<b>ITEM: 6.8</b>	<b>COMMITTEE OF ADJUSTMENT REPORT SUMMARY MINOR VARIANCE APPLICATION FILE NUMBER A179/23 41 DAVOS ROAD, TOWNHOUSE 7, WOODBRIDGE</b>
------------------	---

**COMMITTEE OF ADJUSTMENT REPORT  
MINOR VARIANCE APPLICATION  
A179/23  
41 DAVOS ROAD, TOWNHOUSE 7, WOODBRIDGE**

<b>ITEM NUMBER: 6.8</b>	<b>CITY WARD #: 3</b>
<b>APPLICANT:</b>	Kiran & Kashif Siddiqui
<b>AGENT:</b>	Apex Technical Ltd.
<b>PROPERTY:</b>	41 Davos Road, Townhouse 7, Woodbridge
<b>ZONING DESIGNATION:</b>	See below.
<b>VAUGHAN OFFICIAL PLAN (2010) DESIGNATION:</b>	Vaughan Official Plan 2010 ('VOP 2010'): "Low-Rise Residential"
<b>RELATED DEVELOPMENT APPLICATIONS:</b>	None
<b>PURPOSE OF APPLICATION:</b>	Relief from the Zoning By-law is being requested to permit an existing covered deck and detached garage.

**SITE PLAN**

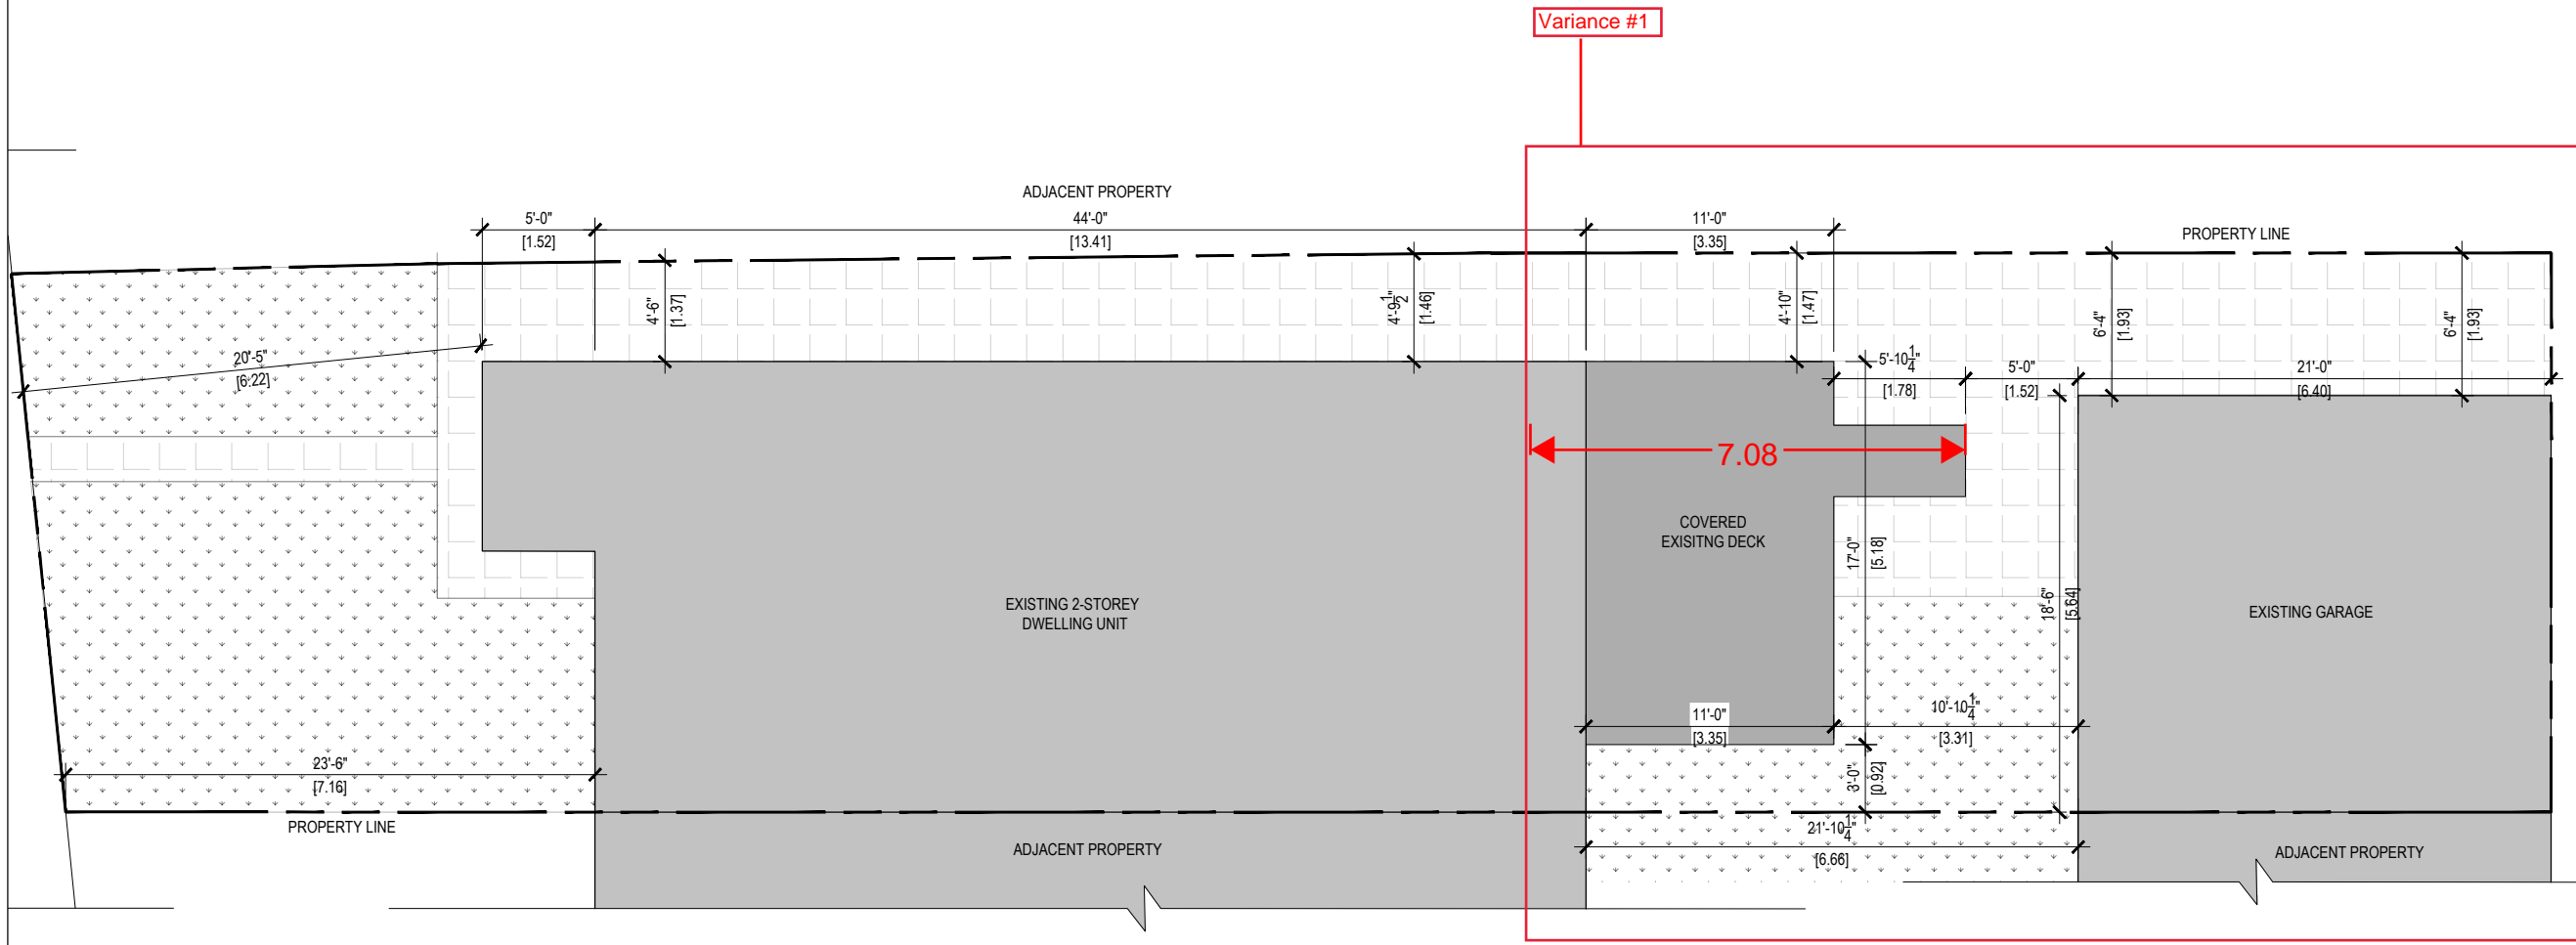
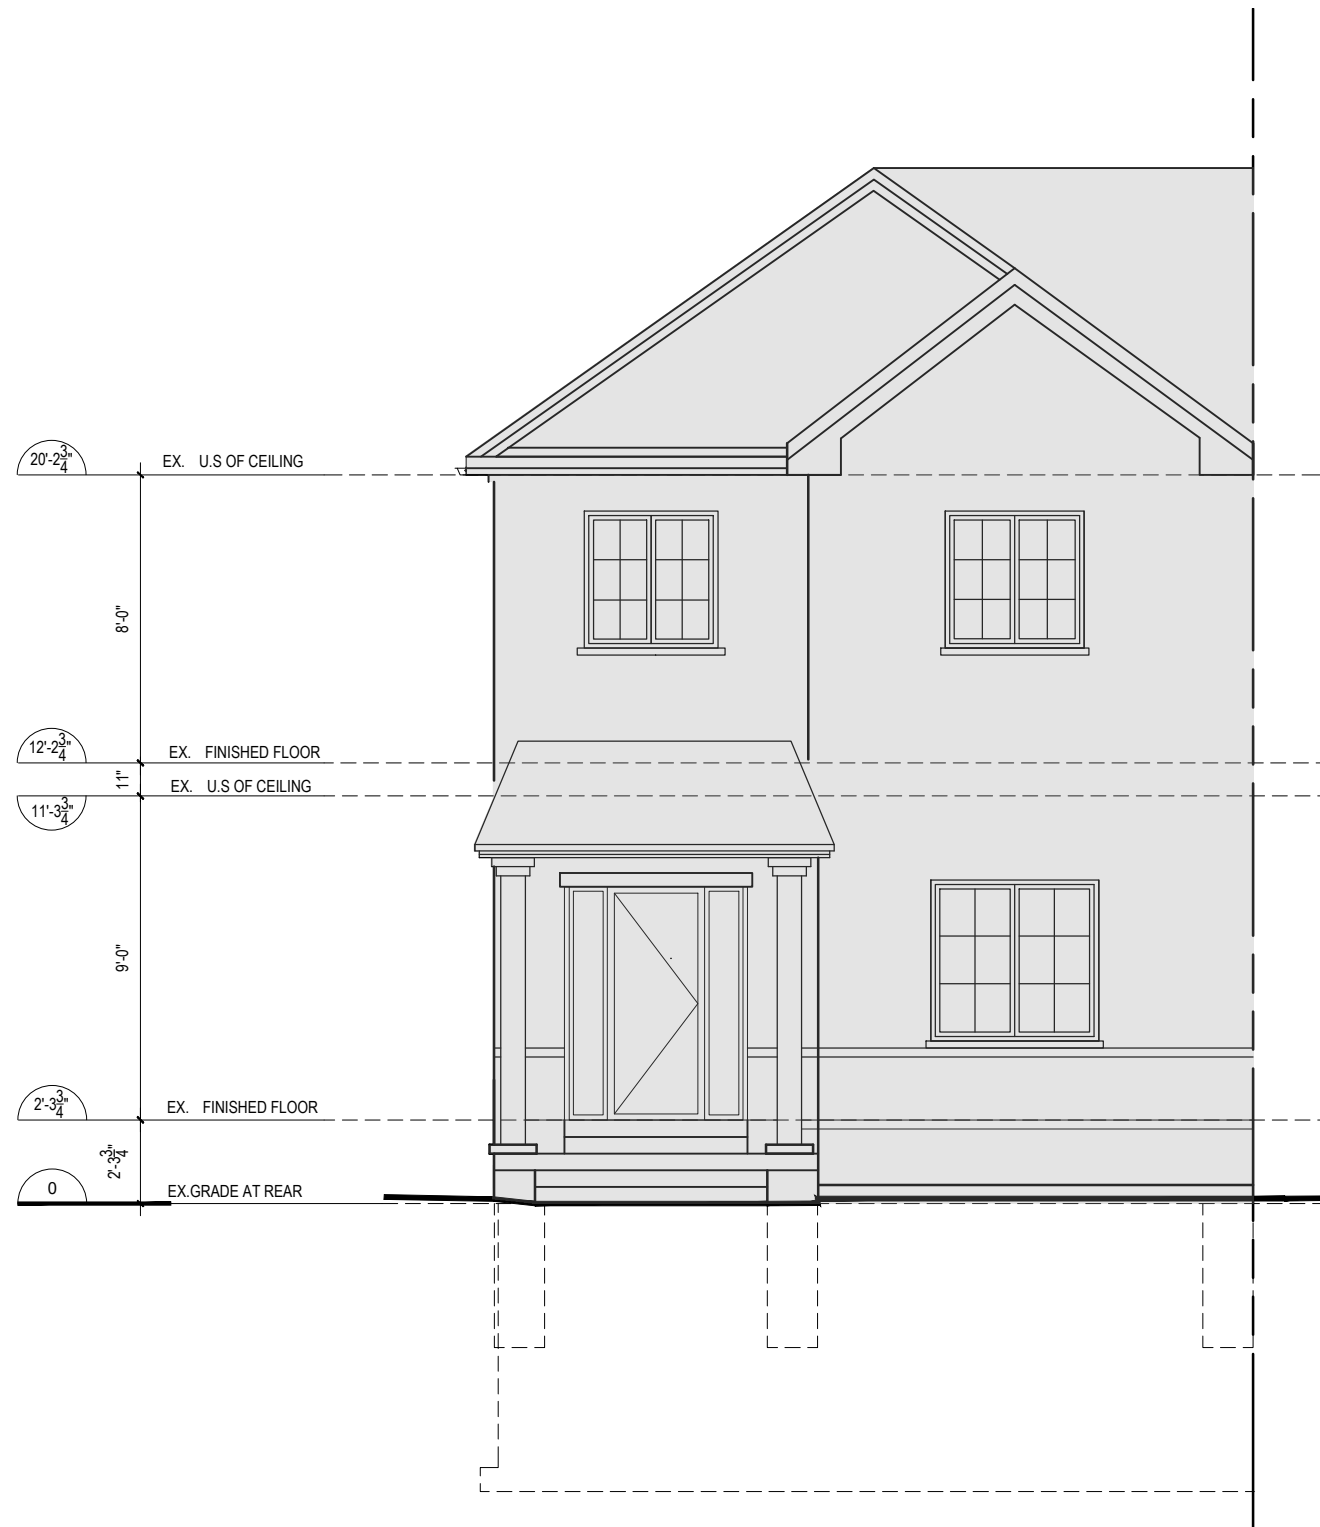
Variance#2

The Development Planning Department has no objection to Variance 1 pursuant to the implementation of the recommended condition. The porch's height is modest, and the walls are open, mitigating potential massing concerns on neighbouring properties. The townhouse block contains a row of garages within the rear yards. The garages are attached to one another but detached from the townhomes. For residential lots that are accessed by a lane within the "RT - Residential Townhouse Zone", the minimum required rear yard is 15.0 metres. The porch's 7.08 metre encroachment into the minimum rear yard setback is anticipated to have minimal use and massing impacts on the neighbouring properties to the east and west as appropriate side yard setbacks are maintained according to the Zoning By-law's requirements.

The Development Planning Department has no objection to Variance 2. The proposed 4.52% increase in maximum lot coverage is negligible from a visual perspective. The porch also maintains the height and interior side yard setback requirements of the Zoning By-law. The proposed increase in lot coverage, with the garage included, still maintains a sufficient rear yard amenity area, and does not adversely impact the functionality of the rear yard. Sufficient uncovered space remains with the rear yard for landscaped outdoor amenity space.

1. That prior to the issuance of a building permit, the owner shall submit photographic evidence to the satisfaction of the Development Planning Department demonstrating that the wood framing above the existing porch stairs has been removed to the satisfaction of Development Planning Department staff.
